LEVEL 10 CONDENSATE SENSOR MARKUP
AGC-8532-SK-LEVEL 10 CONDENSATE SENSOR
MARKUP-161101
Rev 1 - NM - 05/10/2016
Rev 2 - NM - 20/10/2016
Rev 3 - NM

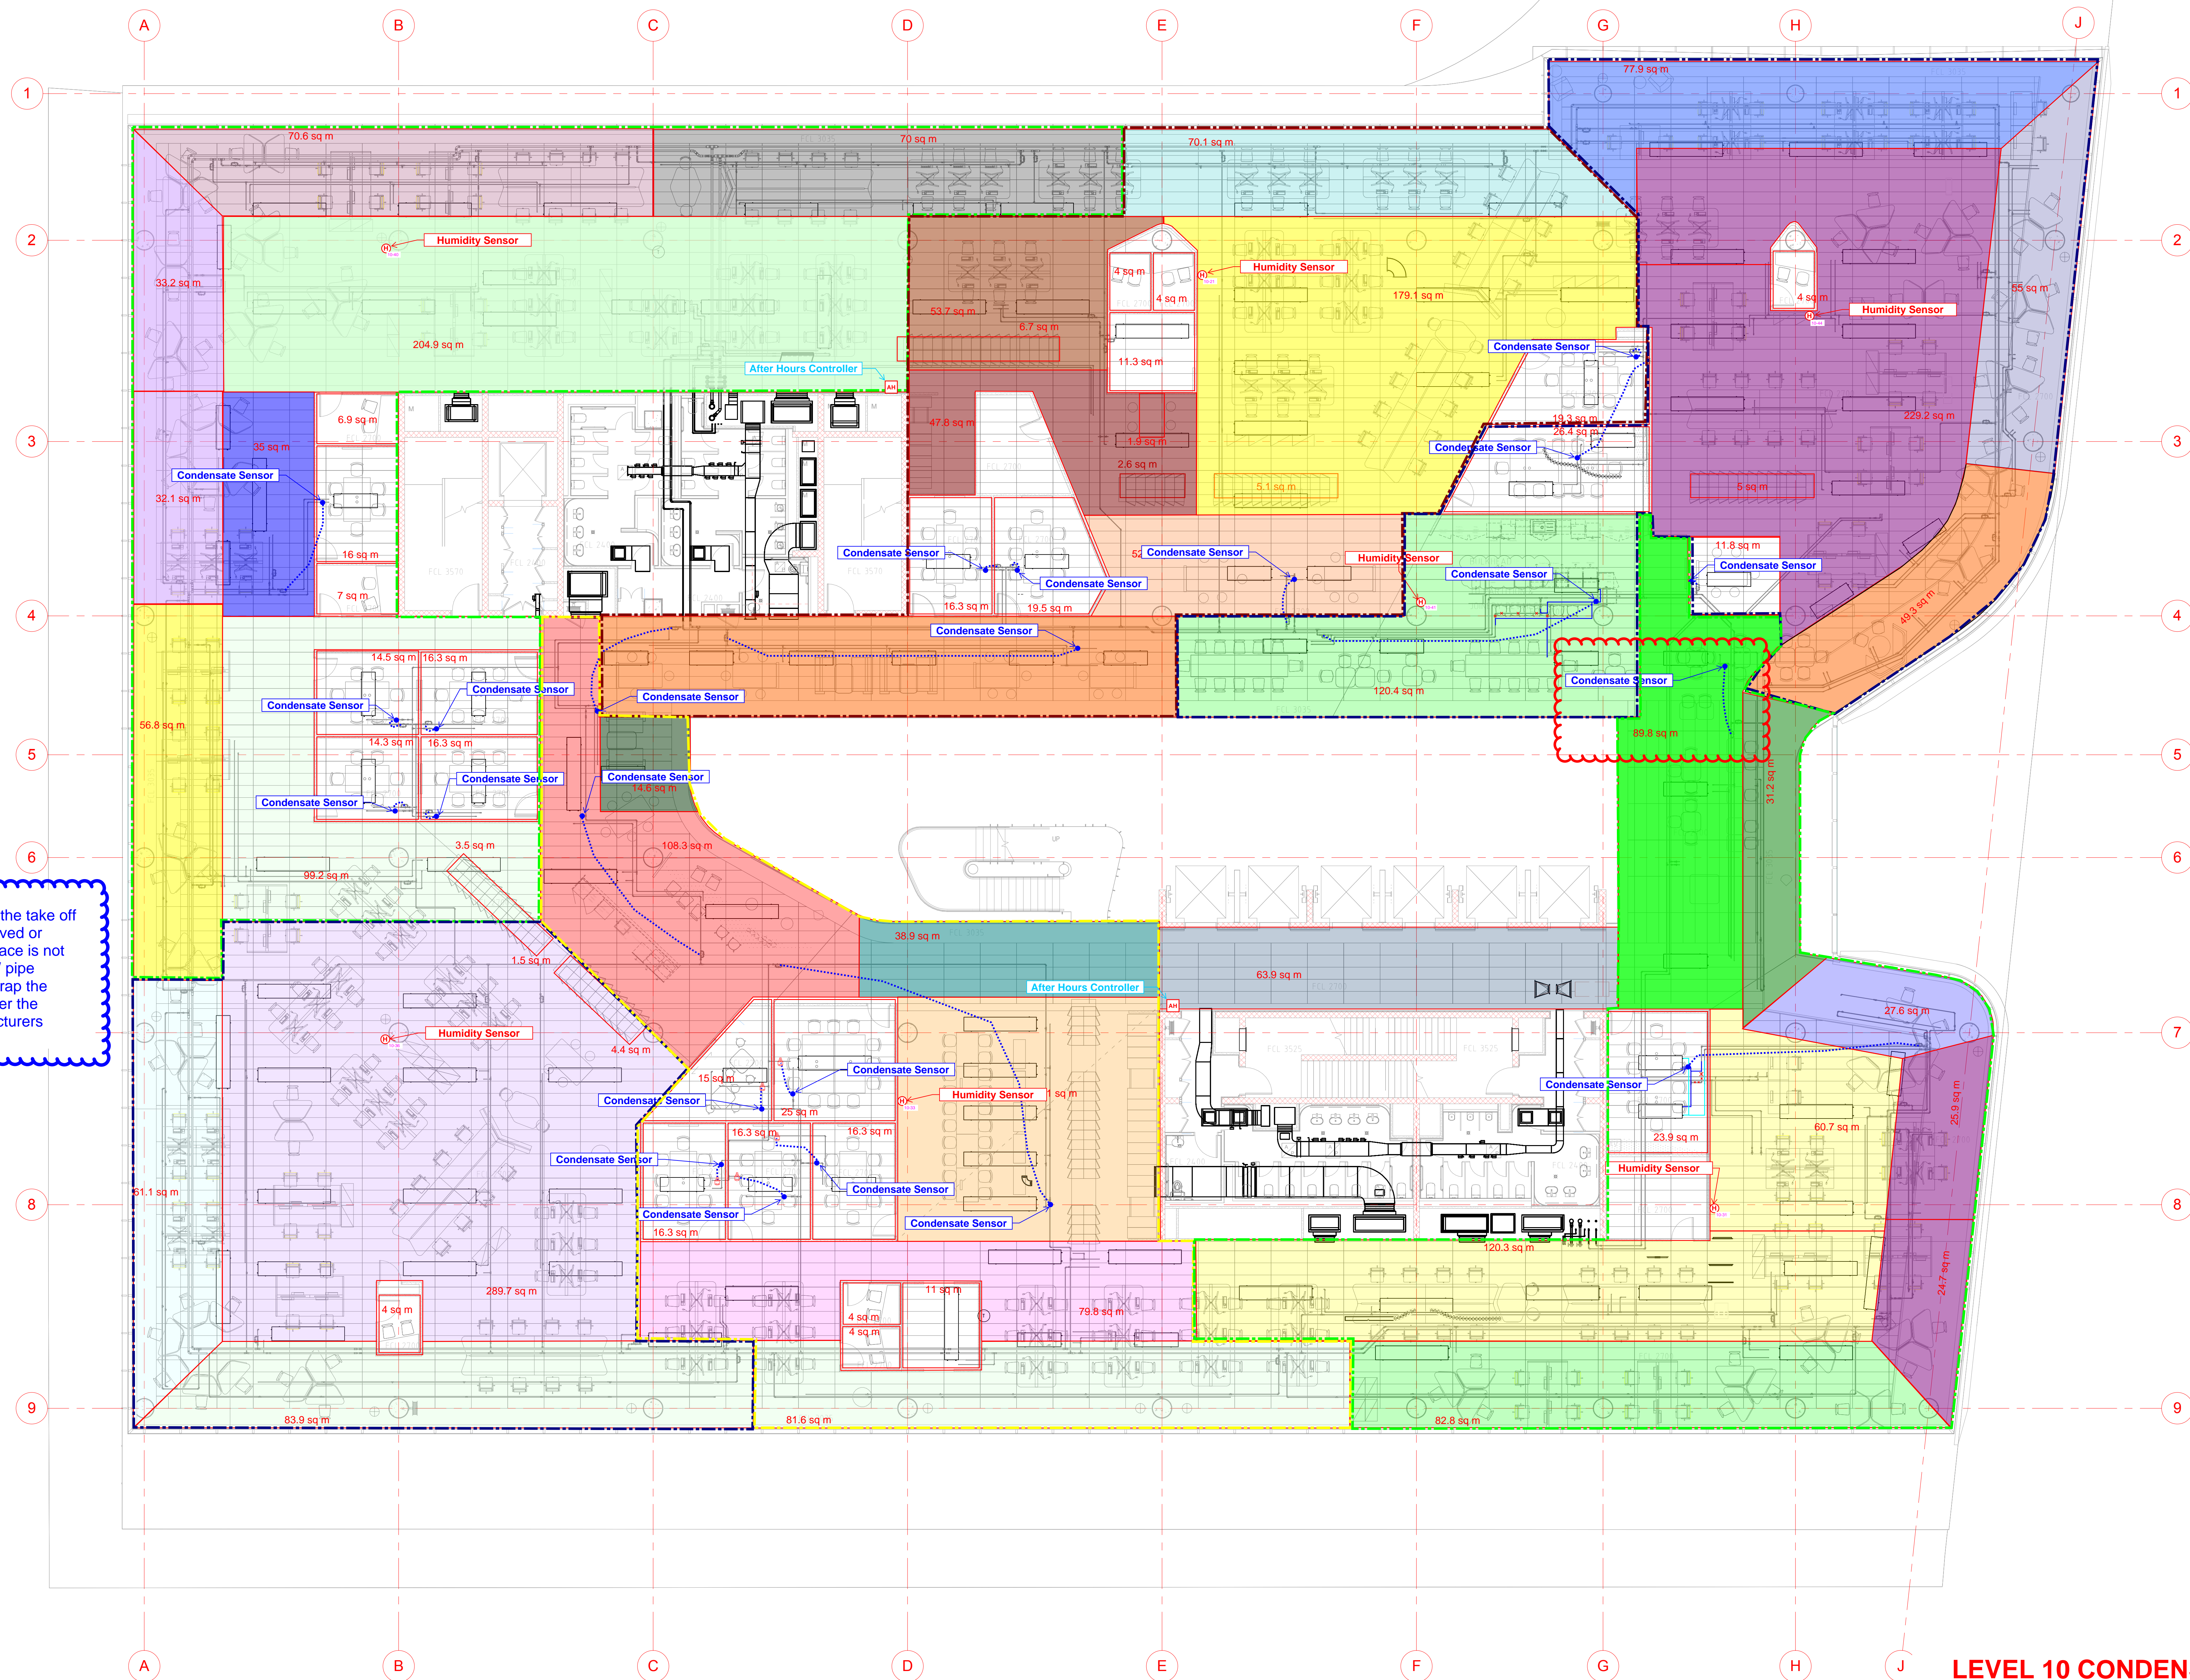
Typical
The condensate sensors at the take off for the first chilled beam served or adjacent to the take off if space is not permitted. Expose the CHW pipe insulation for 100mm and strap the sensor. To be installed as per the condensate sensor manufacturers specification.
